**Pennsylvania Technical Advisory Committee
On Diesel Powered Equipment**

RE: TAC recommendation for requirements for use of a remote crankcase oil breather system on a Deutz BF4M 2011 engine

ATTACHMENT 1

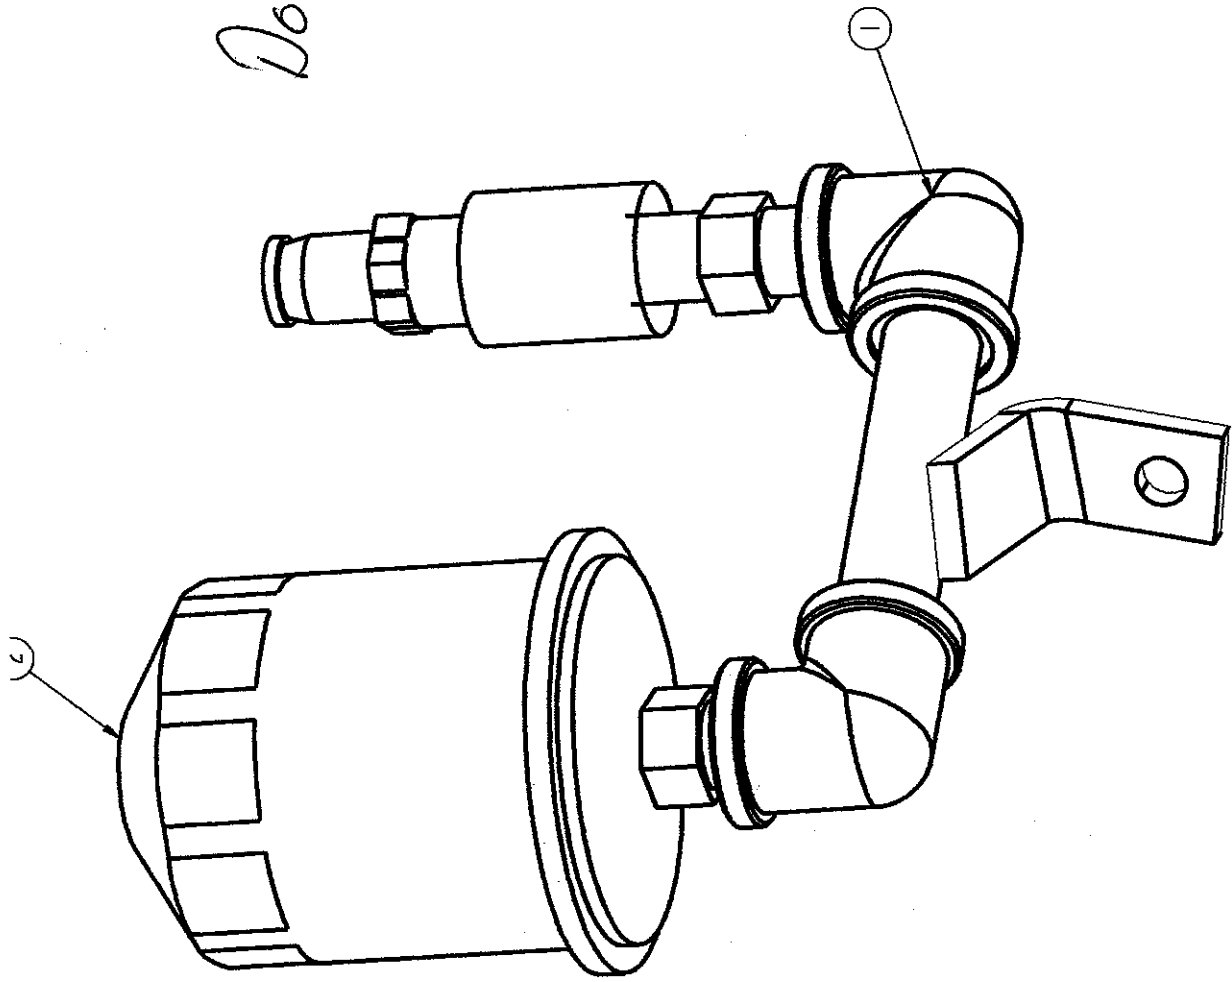
The location of the remote breather was discussed. The filter was installed above the crankcase vent hole so oil could not accumulate in the hose. The TAC questioned the length of the hose used for the remote breather. The frequency of changing the remote breather filter was also discussed. The TAC concern was that the filter may need to be changed more often than the 100 hour maintenance interval.

Therefore, the TAC recommends specific approval of the use of the remote crankcase oil breather system (Attachment 1) on a Deutz BF4M 2011 engine with the following stipulations:

- The filter used on the remote breather system must be an MSHA approved Donaldson filter P550025 which is 95% efficient.
- The filter should be tagged or labeled to identify it as the remote breather filter.
- The pre-op check list should be modified to include a visual check of the filter for excessive oil accumulation on the filter, and change the filter before use if an oil accumulation is found.
- The length of the MSHA approved oil resistant breather hose should not exceed 3 feet in length.
- The 100 hour maintenance check list should be modified to include changing the remote oil filter during every 100 hour maintenance, and also more often if needed.
